Silicon Anomaly List
ADSP-BF522/BF524/BF526(C)
ABOUT ADSP-BF522/BF524/BF526(C) SILICON ANOMALIES

These anomalies represent the currently known differences between revisions of the Blackfin ADSP-BF522/BF524/BF526(C) product(s) and the functionality specified in the ADSP-BF522/BF524/BF526(C) data sheet(s) and the Hardware Reference book(s).

NR003768C

40. 05000457 - Host DMA Port Responds to Certain Bus Activity Without $\overline{\text{HOST_CE}}$ Assertion:

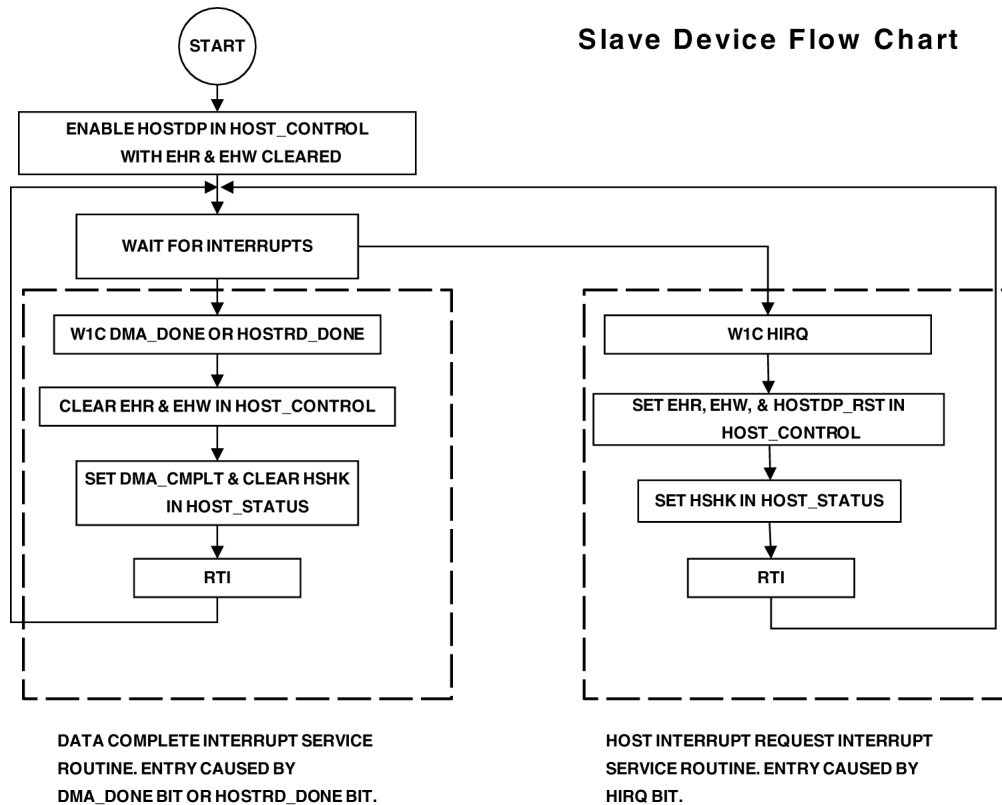
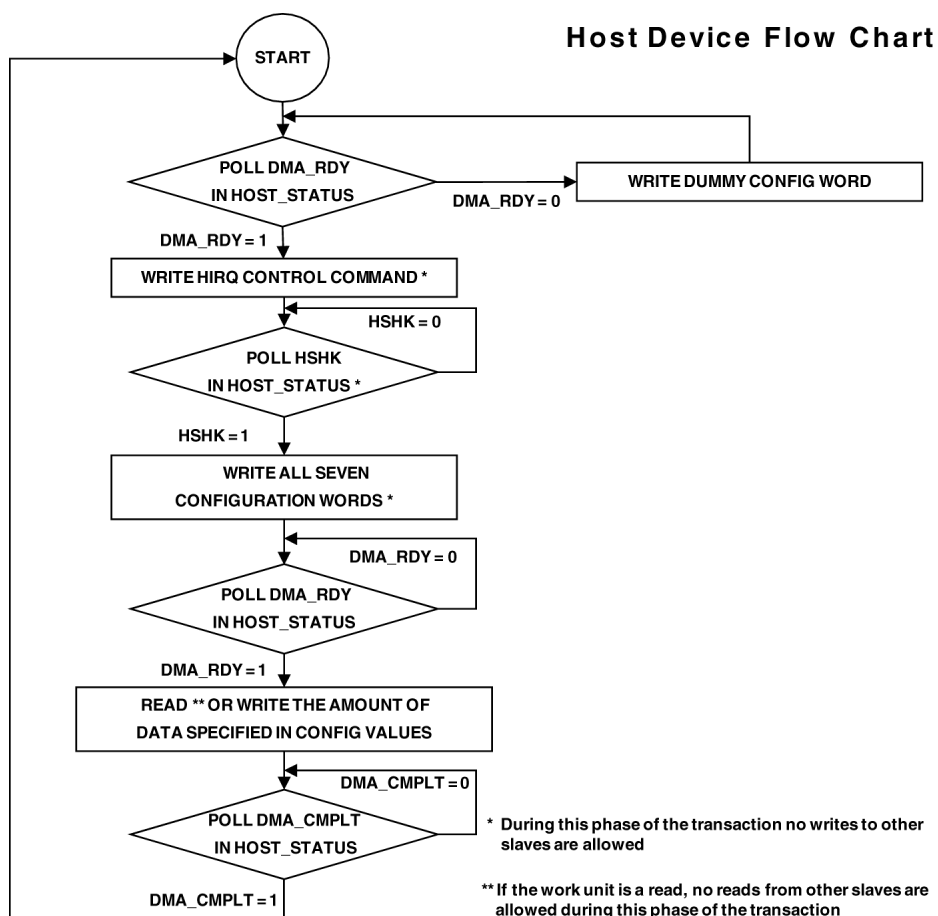
The Host DMA Port (HOSTDP) responds to certain bus activity even without the assertion of its chip enable, $\overline{\text{HOST_CE}}$. If the HOSTDP is the only slave on the bus (meaning that $\overline{\text{HOST_WR}}$ and $\overline{\text{HOST_RD}}$ are asserted by the host only for communicating with the HOSTDP), this anomaly will not be observed. There are two states in which the HOSTDP responds to bus activity (assertion of $\overline{\text{HOST_WR}}$ or $\overline{\text{HOST_RD}}$) without $\overline{\text{HOST_CE}}$ being asserted:

1. HOSTDP is Enabled and Waiting for the Host to Configure - While waiting for configuration in both acknowledge and interrupt modes, assertions of $\overline{\text{HOST_WR}}$ for other slaves can cause the HOSTDP to be erroneously configured.
2. HOSTDP is Configured for Data Reads - While waiting for data reads in both acknowledge and interrupt modes, assertions of $\overline{\text{HOST_RD}}$ for other slaves can cause the HOSTDP to subsequently return data out of order.

- a. Add additional logic - Connect to $\overline{\text{HOST_WR}}$ through a 2-input OR gate where one input of the OR gate is the host's write signal and the other is the host's chip select.
- b. Time bus accesses by the host processor - Do not write to other slaves on the bus between the time that the HOSTDP is enabled and the DMA_RDY bit in HOST_STATUS is set.
- c. Change the software on both the host and the slave as shown in the following flowcharts:

- a. Add additional logic - Connect to $\overline{\text{HOST_RD}}$ through a 2-input OR gate where one input of the OR gate is the host's read signal and the other is the host's chip select.
- b. Time bus accesses by the host processor - Do not read from other slaves on the bus between the time that the final configuration word (YMODIFY) is written to the HOSTDP and the DMA_CPLT bit in HOST_STATUS is set.
